Rezoning Transportation Analysis

Petition Number: Insert Zoning Petition # 2021-008

General Location Identifier: Tax ID 22120202

Revision Log:

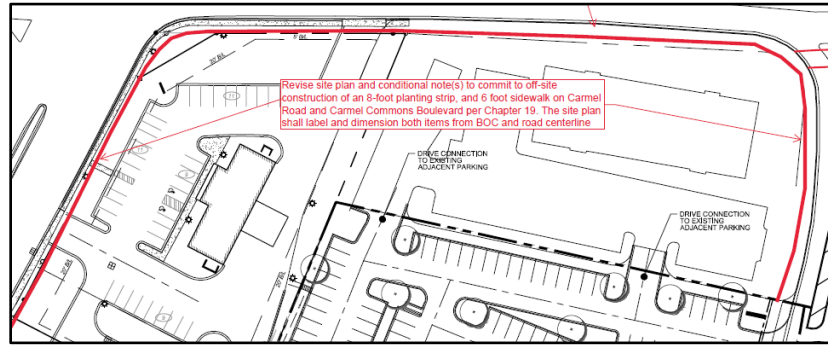
2. Traffic Study:

A Traffic Impact Study is necessary for the complete review of this petition due to the site generating more than 2,500 daily trips.

Staff will receive the petition and begin review, but the public hearing will not be scheduled until the TIS is approved to allow for the minimum time necessary for CDOT to review the study and reach agreement with the petitioner on the required transportation commitments. Any agreed upon commitments shall be included on the last site plan submitted no fewer than 4 weeks prior to the public hearing. Therefore, additional traffic mitigation comments may be forthcoming once the TIS is approved by CDOT (and NCDOT).

Updated to Comment as a Result of 04-12-2021 Site Plan: Pending approval of the TIS, the site plan and conditional notes will need to be revised to incorporate the established transportation improvements.

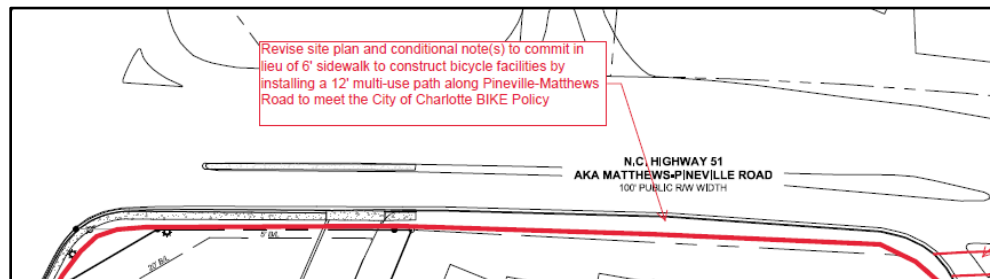
4. Revise site plan and conditional note(s) are needed to commit to installing an 8-foot planting strip and 6-foot sidewalk along Pineville-Matthews Road per Ch. 19, however, CDOT would prefer a 12-foot multi-use path allowing for a bicycle facility meeting the City Charlotte BIKE Policy.

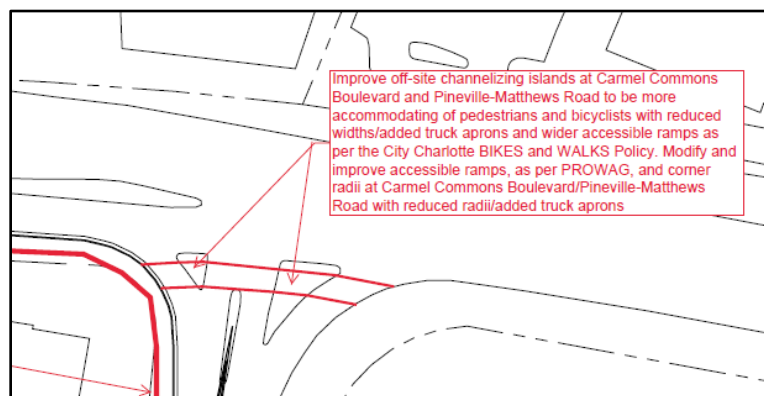
5. ~~Revise site plan and conditional note(s) to commit to improve off-site channelizing islands at Carmel Commons Boulevard and Pineville-Matthews Road to be more accommodating of pedestrian and bicycles as per ADA/PROWAG, City of Charlotte WALKS and BIKES Policy. Modify and improve accessible ramps, as per PROWAG, and corner radii at Carmel Commons Boulevard/Pineville-Matthews Road with reduced radii/added truck aprons.~~

Updated to Comment as a Result of 04-12-2021 Site Plan: Revise the conditional notes by including a note committing to these ADA Improvements.

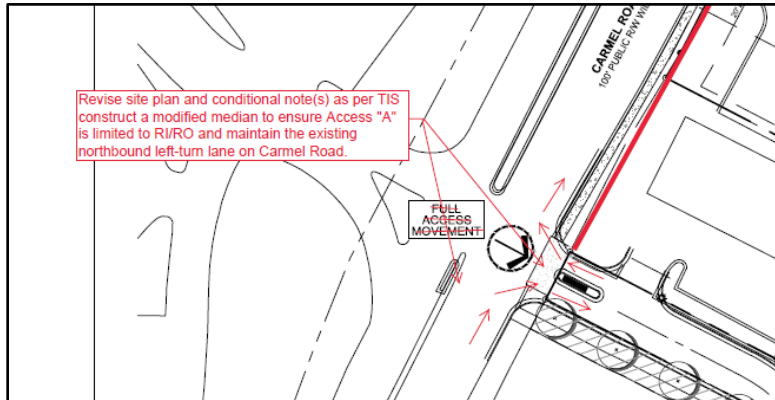
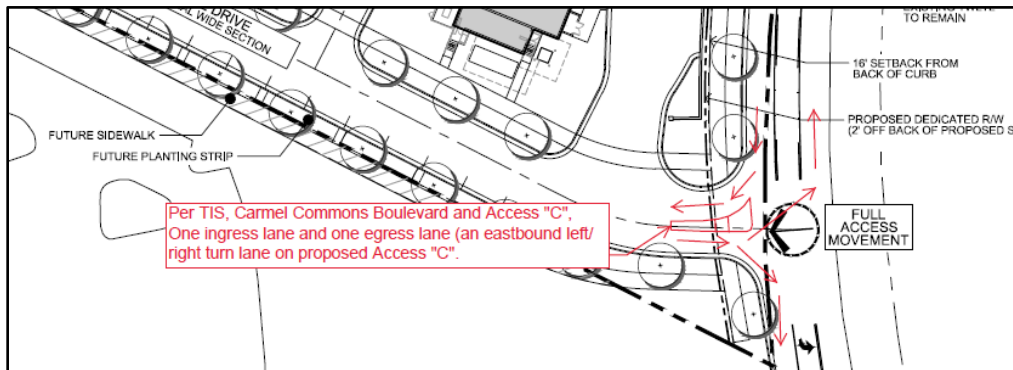
6. ~~Revise site plan and conditional note(s) per TIS report to construct a modified median to ensure Access "A" is limited to right in/right out (RIRO) and maintain the existing northbound left-turn lane on Carmel Road. CDOT prefers constructing a directional crossover with raised concrete median islands.~~

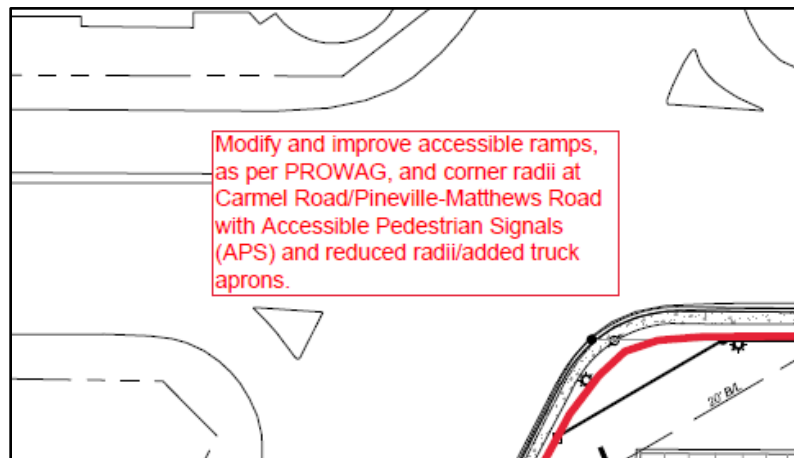
7. ~~Revise site plan and conditional note(s) per TIS report to show one ingress lane and one egress lane with an eastbound combined left/right turn lane on proposed Access "C" on Carmel Commons Boulevard. CDOT prefers the construction of a raised concrete median island or a pedestrian refuge to prevent prohibited movements.~~

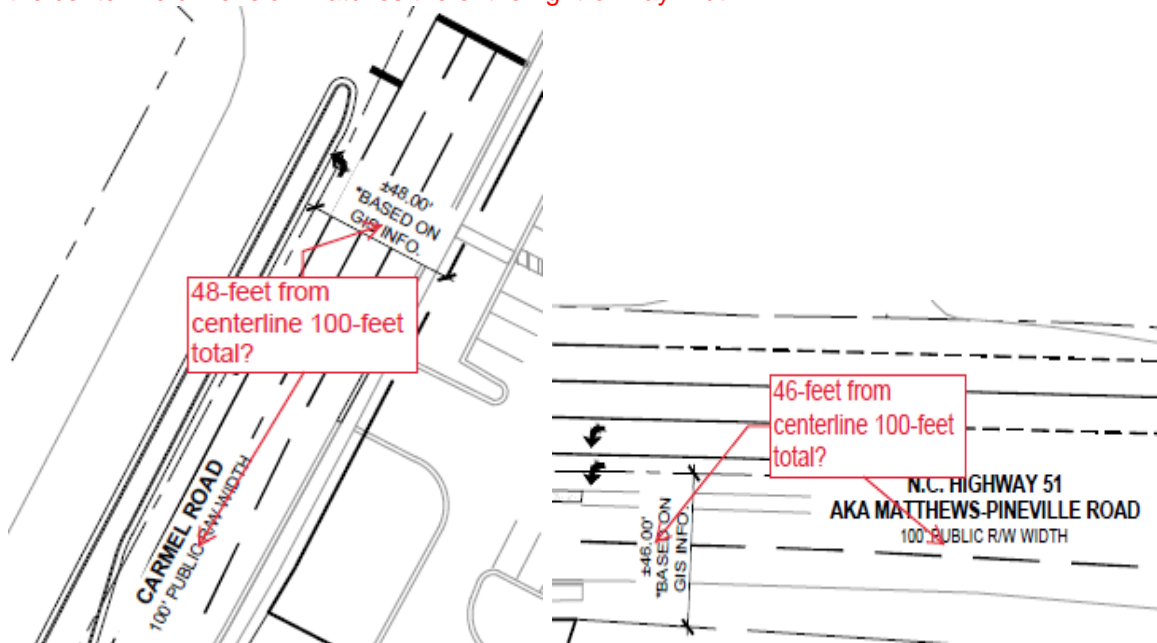
8. Modify and improve accessible ramps, per PROWAG, and corner radii at Carmel Road/Pineville-Matthews Road with Accessible Pedestrian Signals (APS) and reduced radii/added truck aprons.
- Outstanding Comment from 03-25-2021**
